HUDDERSFIELD

DESIGN & ACCESS STATEMENT ADDENDUM

SEPTEMBER 2024

Fig. 6.1.6 Proposed Amended Plan - Upper Ground Floor Plan

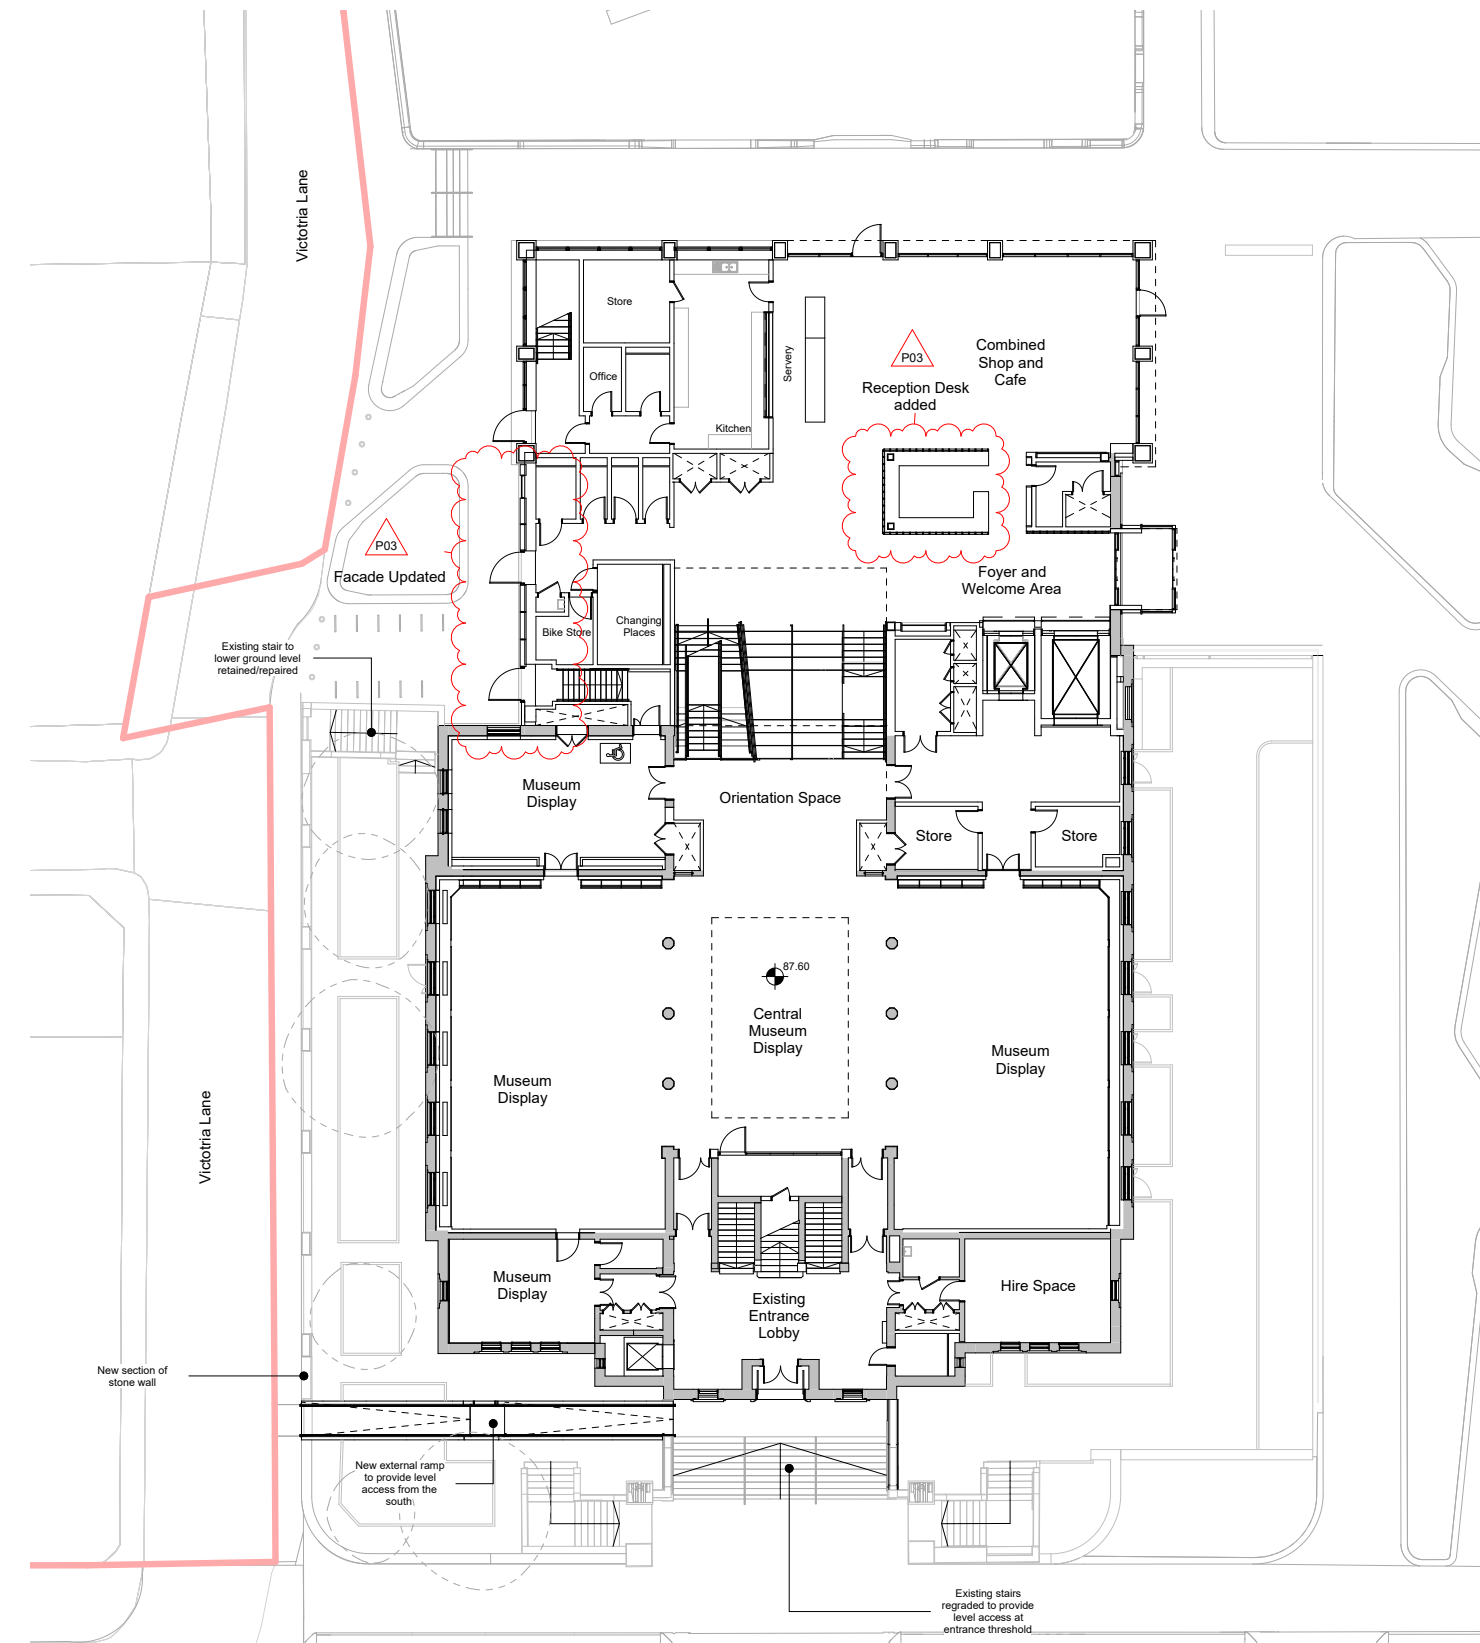
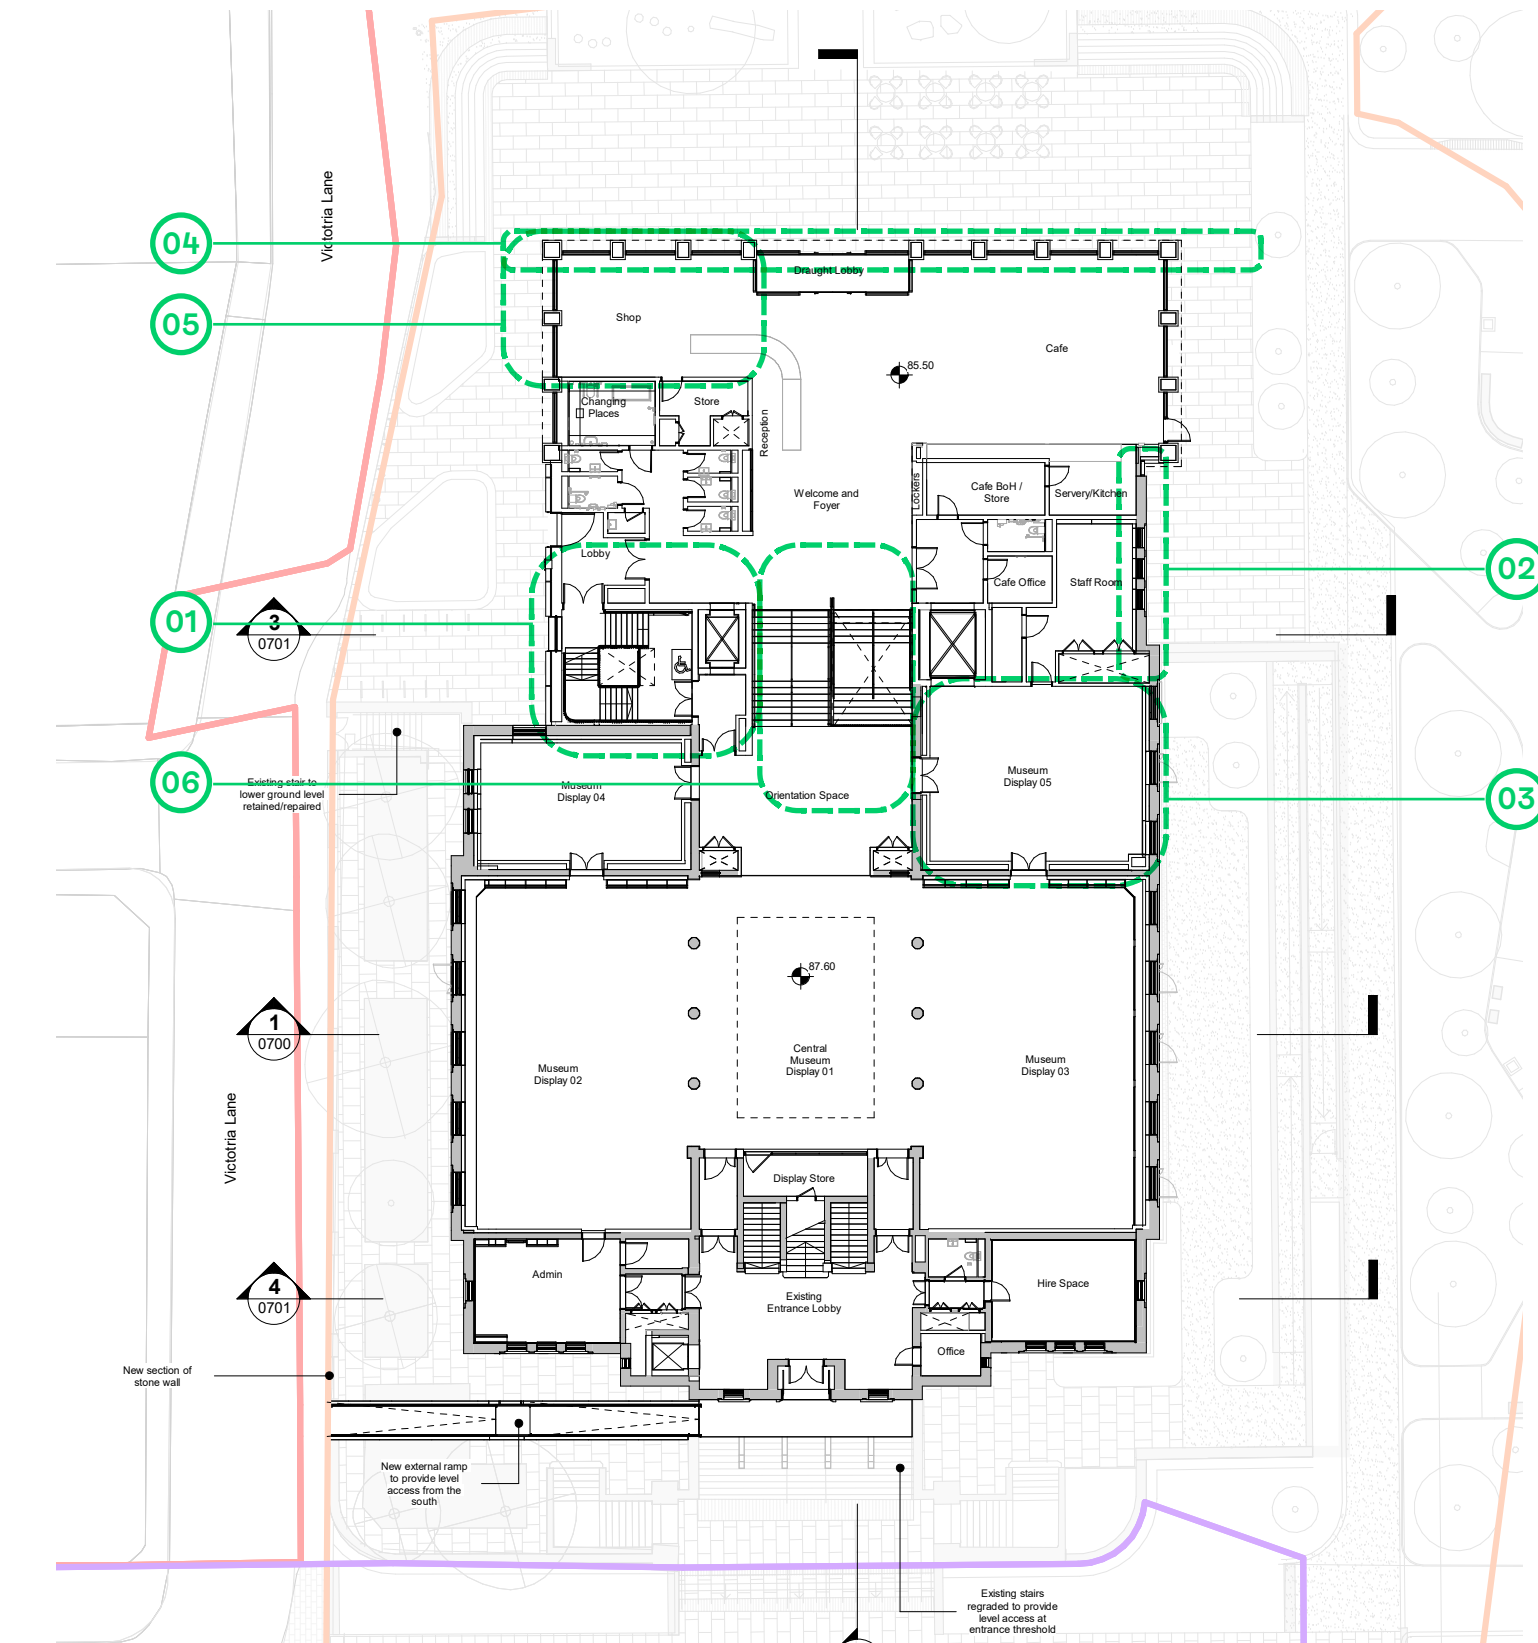
- 01 Rationalisation and relocation of stair core and lifts. Changes reduce intervention to existing North facade.
- 02 Previous new entrance through east elevation omitted, providing greater retention of existing fabric.
- 03 Amendments to existing east facade enables existing room extents to be retained and used as Museum Display.
- 04 New entrance added to North facade providing better relationships to the proposed new park alongside the existing building. Facade piers updated inline with new entrance.
- 05 North west stair core omitted, providing increased active frontage.
- 06 Feature stair between upper and lower ground floor updated to provide better visibility and connectivity between floors.

Fig. 6.1.8 Proposed Amended Plan - Level 01 Floor Plan

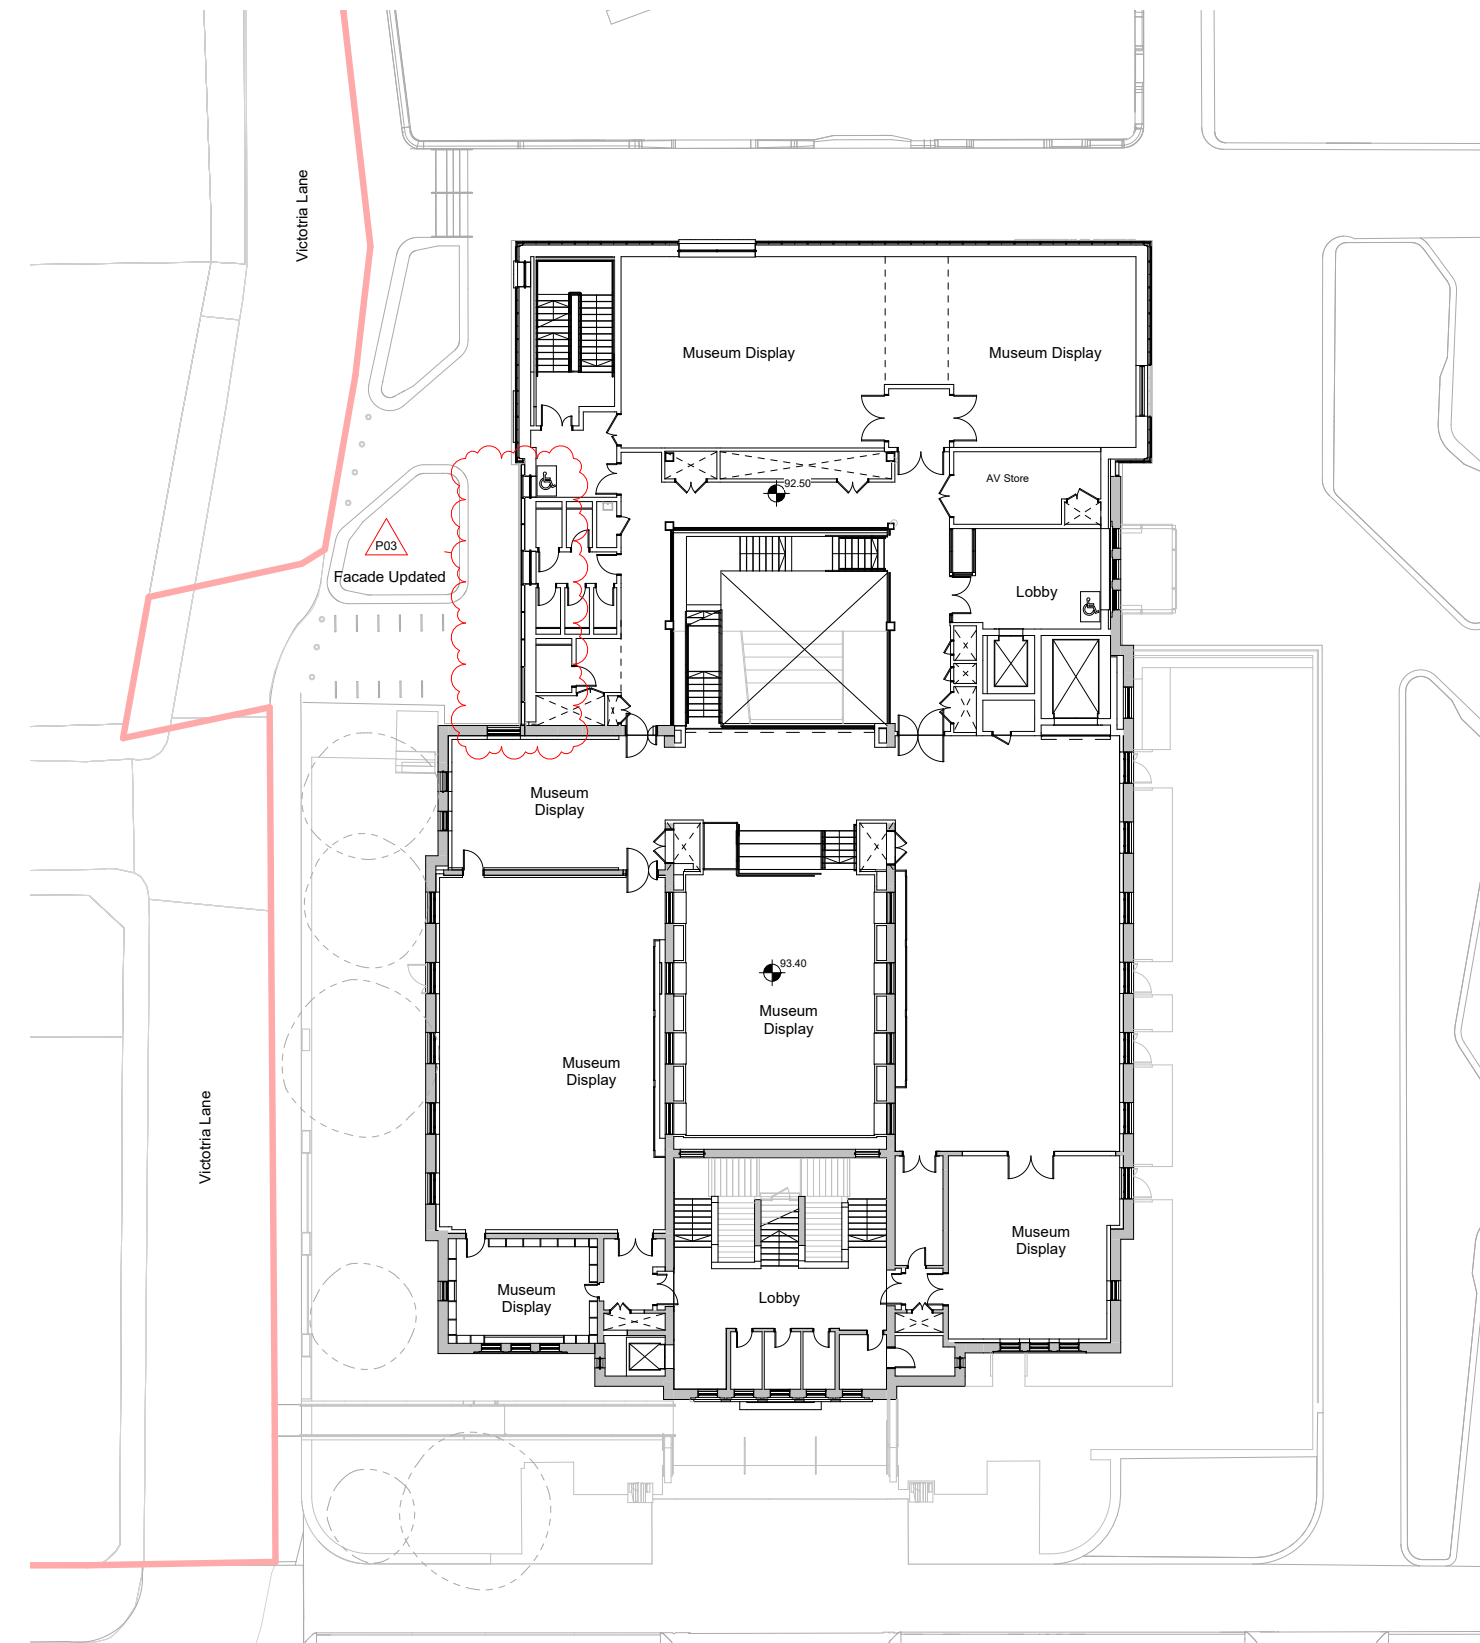
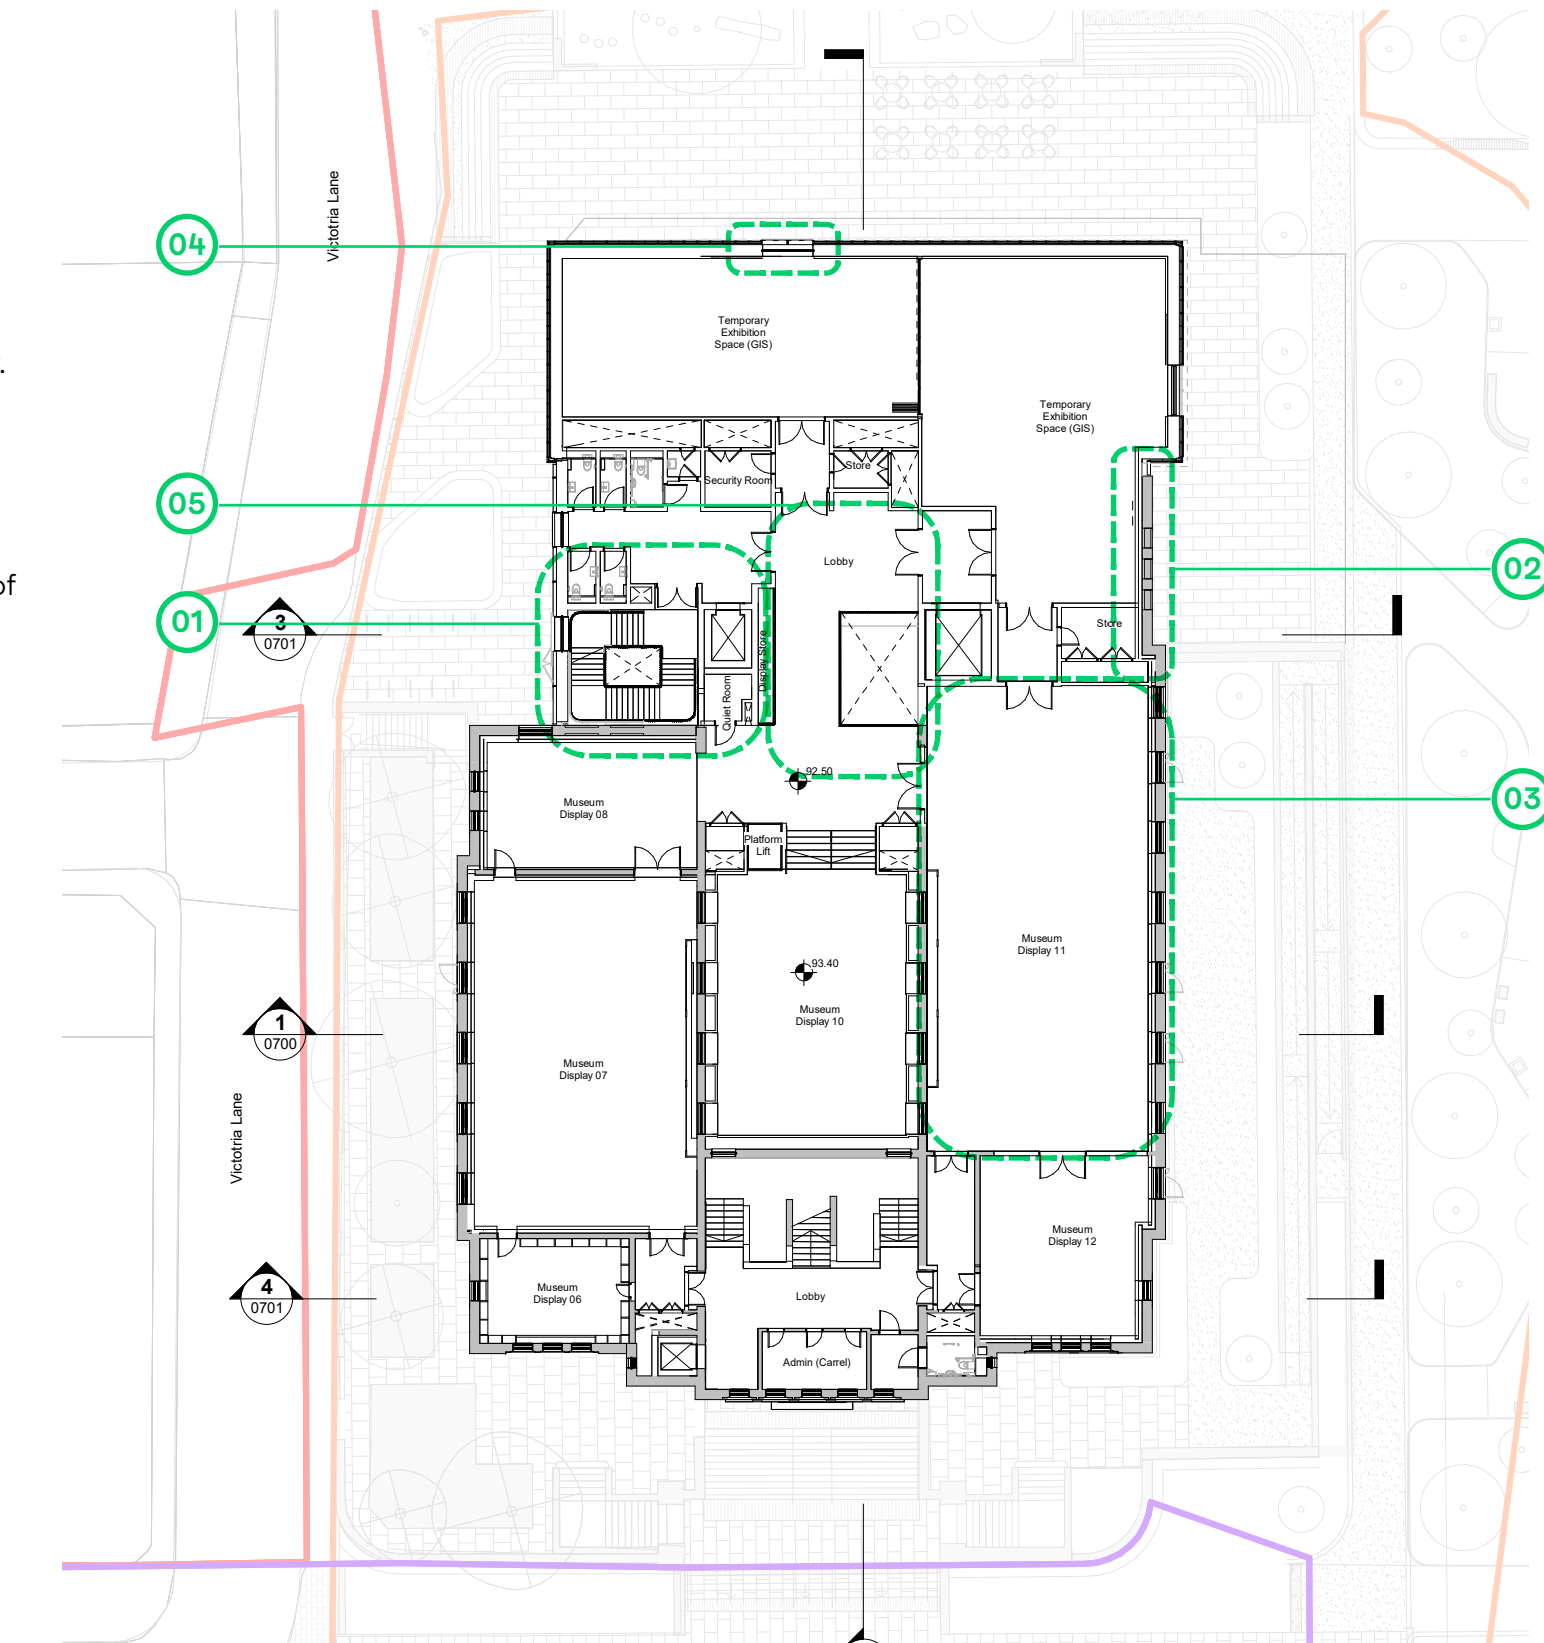
- 01 Rationalisation and relocation of stair core and lifts. Changes reduce intervention to existing North facade.
- 02 Existing eastern windows to level 01 infilled to provide greater flexibility to the Temporary Exhibition Display space.
- 03 Amendments to existing east facade enables existing room extents to be retained and used as Museum Display.
- 04 Window locations of North facade updated to align with internal layout changes.
- 05 Feature stair omitted and new atrium design to provide addition area for Museum and Art Gallery display whilst providing visibility and good user flow between floors. Roof light above amended to suit new design.
